Service Bulletin

Subject: Electric Contactor Box Transient Voltage Suppression Harness

Models: All Electric Touch Screen Fryers

10/05/2022

Figure 1 Box prior to 2206 with harness added.

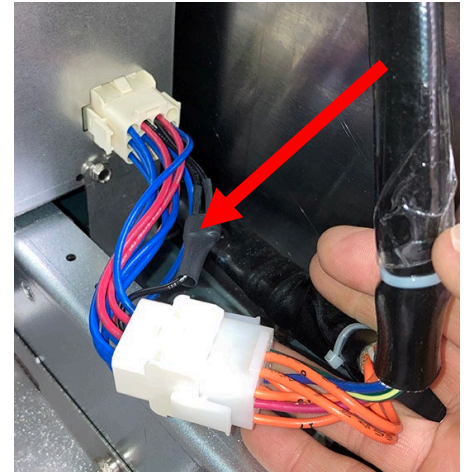
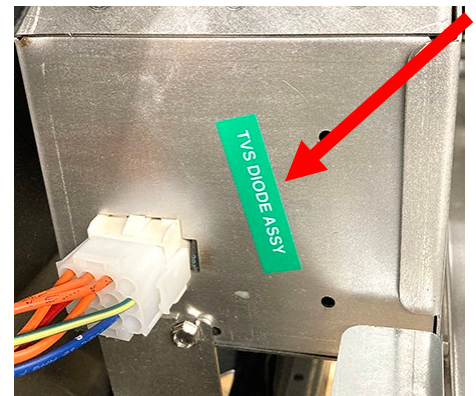
Frymaster **ELECTRIC** Touch Screen Fryers with serial numbers **prior to 2206**, may experience issues with the touch screen controller randomly rebooting and/or SIB (Smart Interface Board) errors, due to electromagnetic interference.

If a fryer is exhibiting these symptoms, attaching an intermediate transient voltage suppression harness (see Figure 1), between the contactor box and contactor box harness will address these issues. Units built 2206 and after have the upgrade integrated into the contactor box assembly (noted by the sticker on the box).

If a fryer has these issues, order enough 8263720 kits for each contactor box in the affected fryer. If more than one fryer is in a store, order enough kits to address both fryers in the store.
